# CITY OF ALBUQUERQUE

## INTER-OFFICE MEMORANDUM

**SUBJECT:** **AC-24-23, VA-2024-00231, PR 2022-006844**

**Frank T. Cloak** appeals the Site Plan-Administrative decision to approve a Site Plan for all or a portion of TRACT A THE PEARL ADDITION (being a replat of Tracts 107-B, 107-C together with Tract 106-A within projected Section 18 T10 N, R3E) zoned MX-M and R1-A, located at 1701/1623 Central Avenue, NW containing approximately 0.5767 acre(s). (J-13)

Figure 3. Site Plan layout with Open Space shown to the north in grey with 'pink' hatched lines.

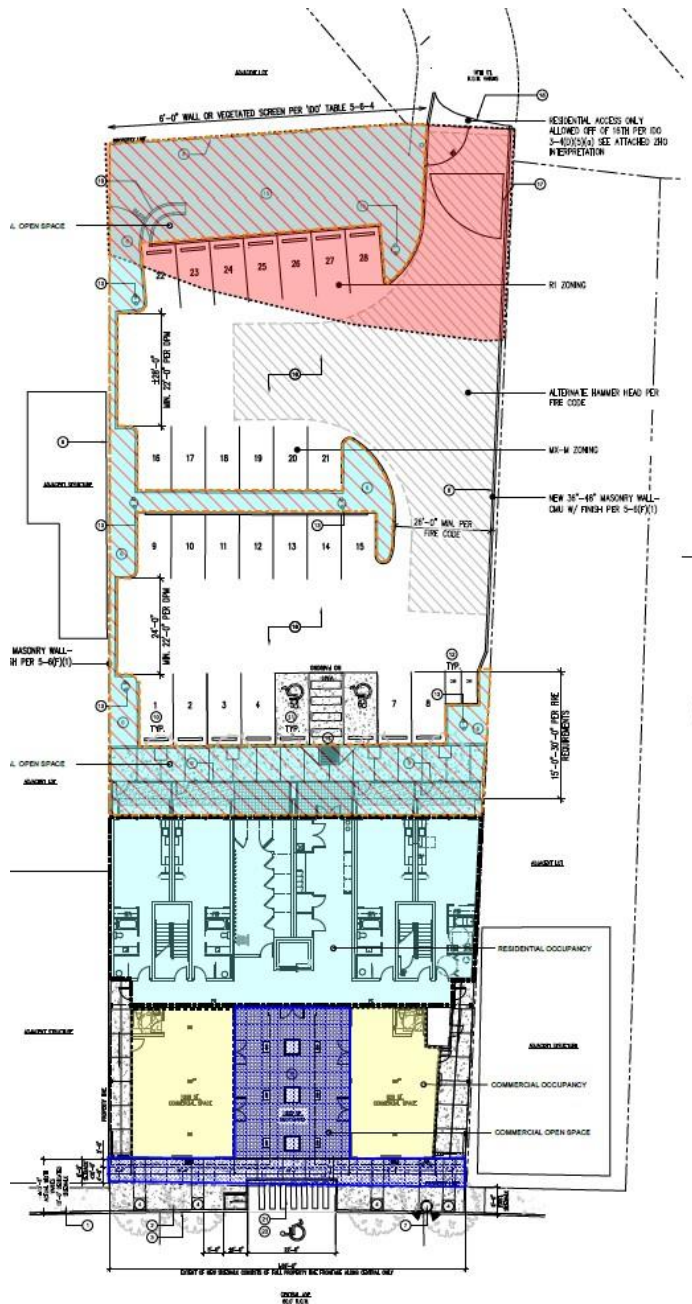
2. **Appellant:** The developer should be required to find another means of ingress and egress from his parking lot. A novel solution would be to provide a car free building (as outlined by appellant) and turn the parking area into a park.

**Staff Response:** The site plan administrative review is done to determine compliance with the IDO. Staff cannot require the applicant to consider a different layout if their proposed site plan is compliant with the IDO.

The site plan that was approved includes a large open space area on the north end of the project.
